# IEEE P802.3bt PSE State Diagram Update

Dan Dove, DNS for LTC

*April 27, 2015*

# Defining Blocks & Identifying Arcs

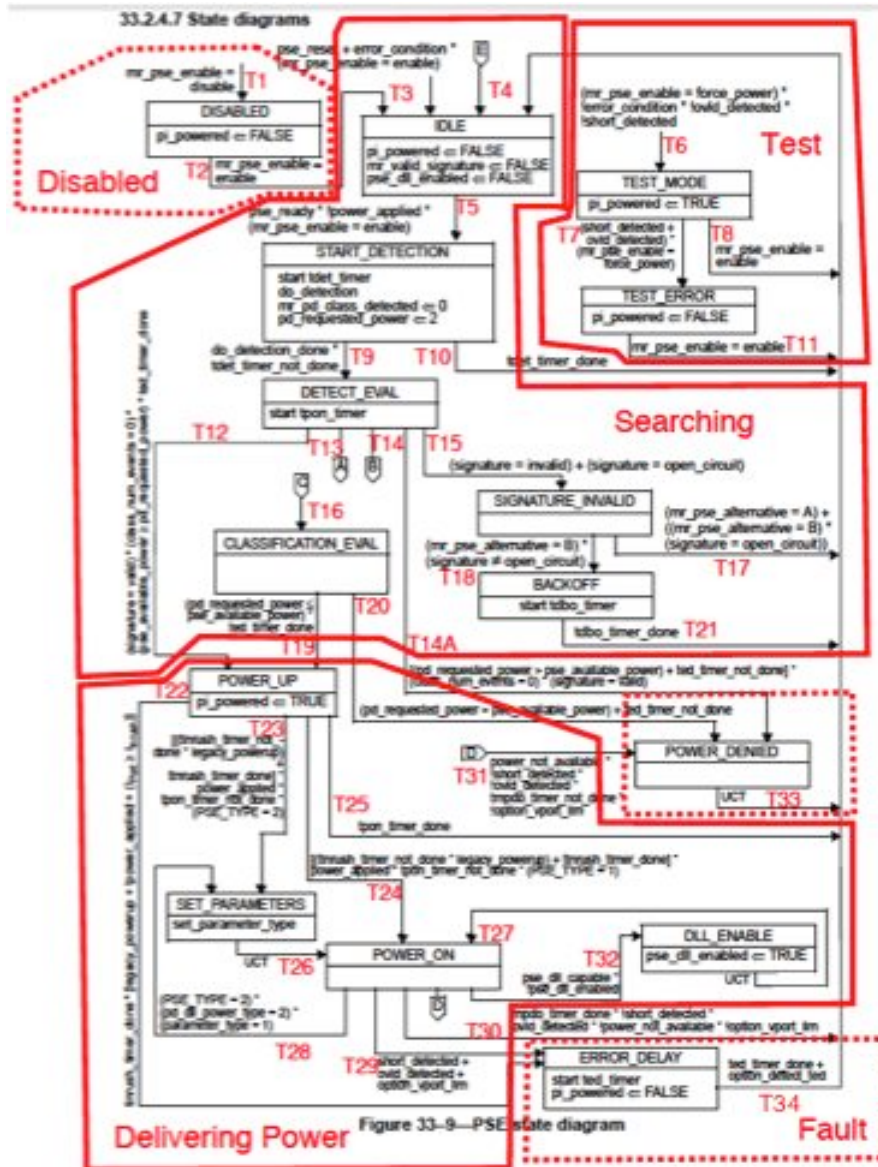
Removed T35

Moved T34 (already T27) to Fault  
output to RTI (Formerly T35)

# Searching

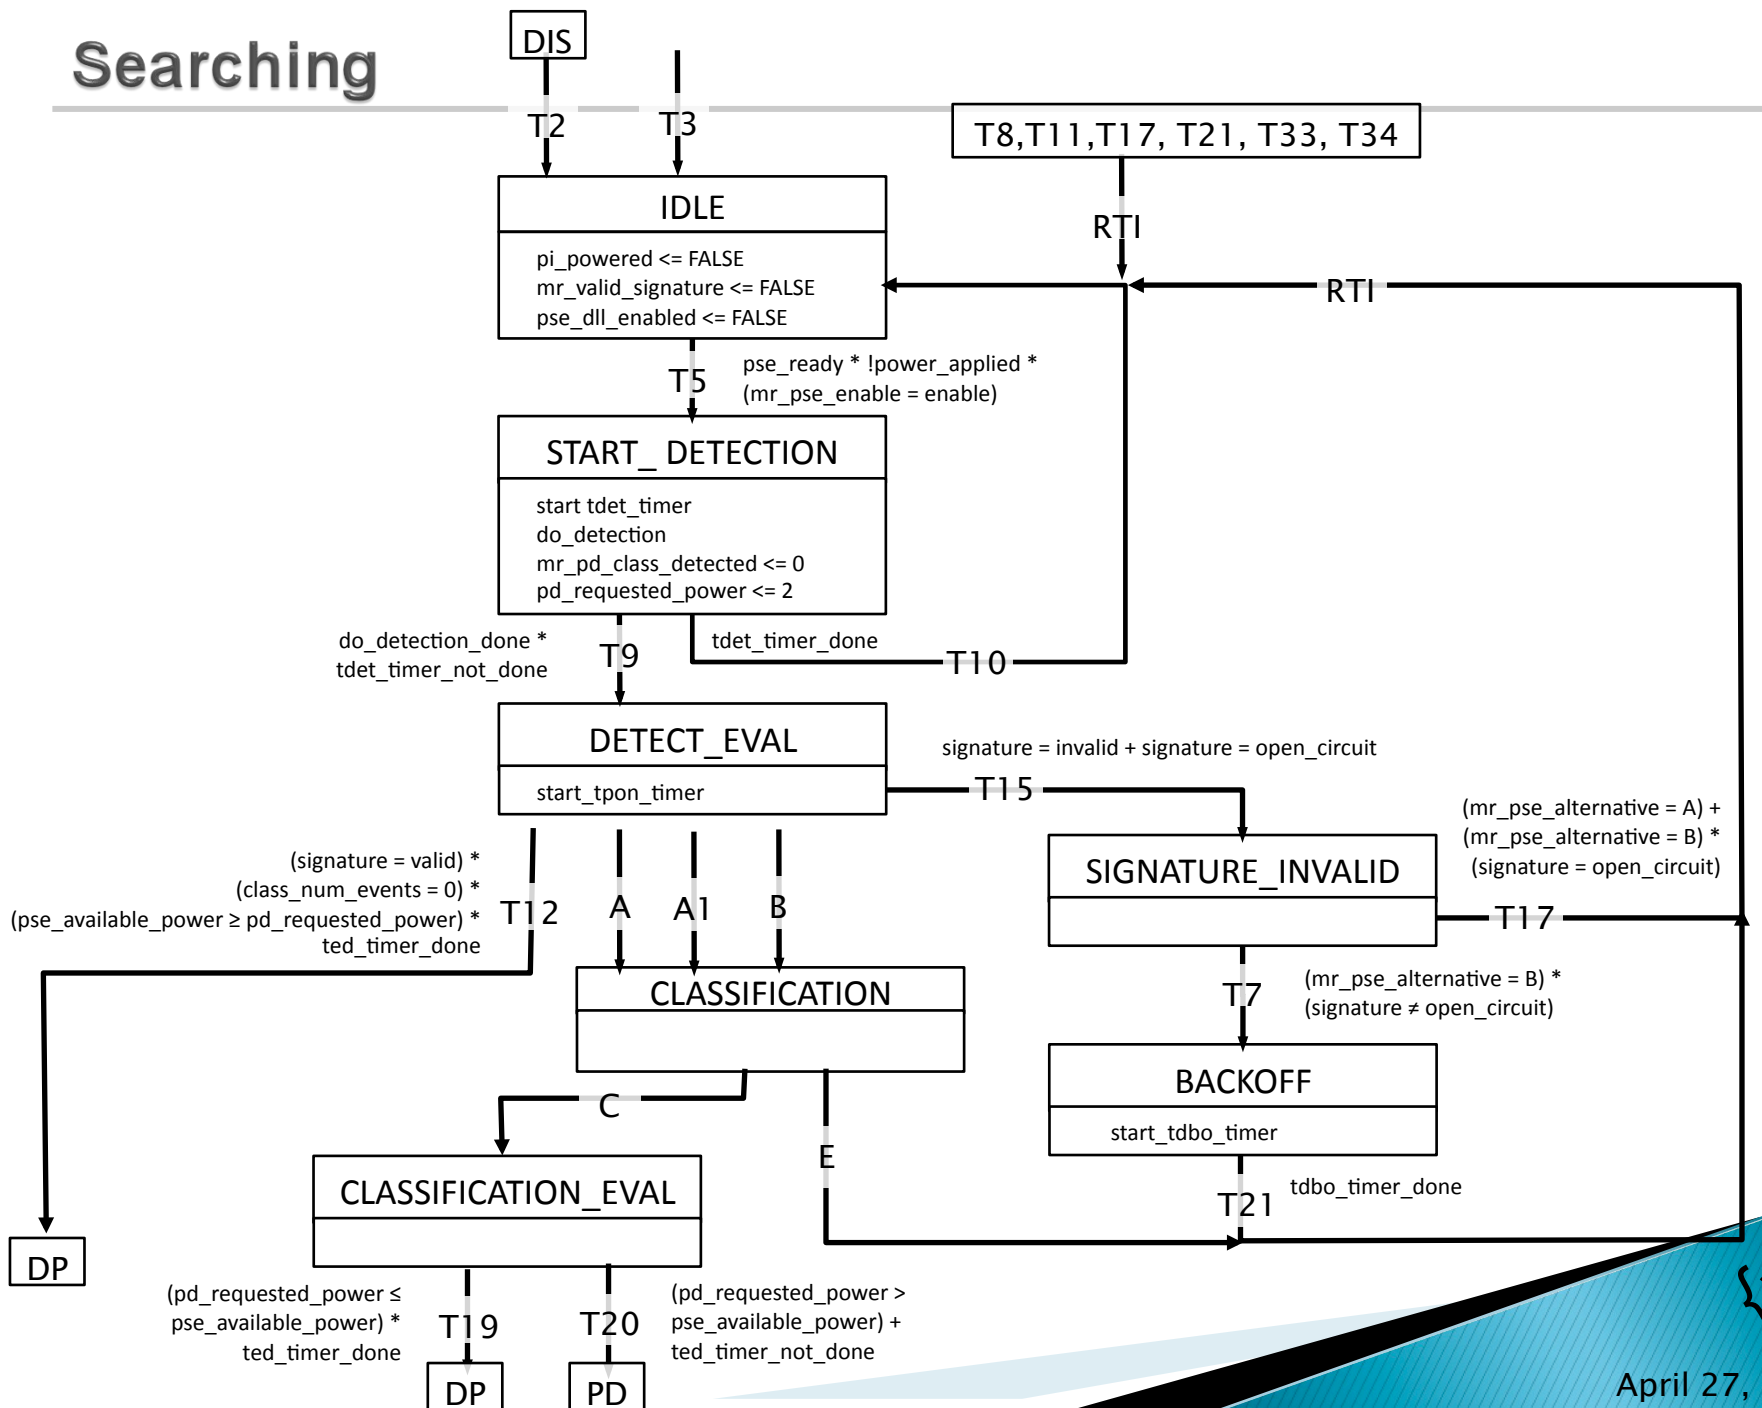
- A typo taken out of T23 (removed hyphen)
  - A1 arc added to “Searching” block since it appears as entry into the Classification State
- It’s the author’s opinion, that a good specification is done from the top down, rather than the bottom up. The existing PSE state diagram, while it accurately represents behavior of a PSE, appears to have been designed from the bottom up to explain PSE behavior, rather than to direct design.
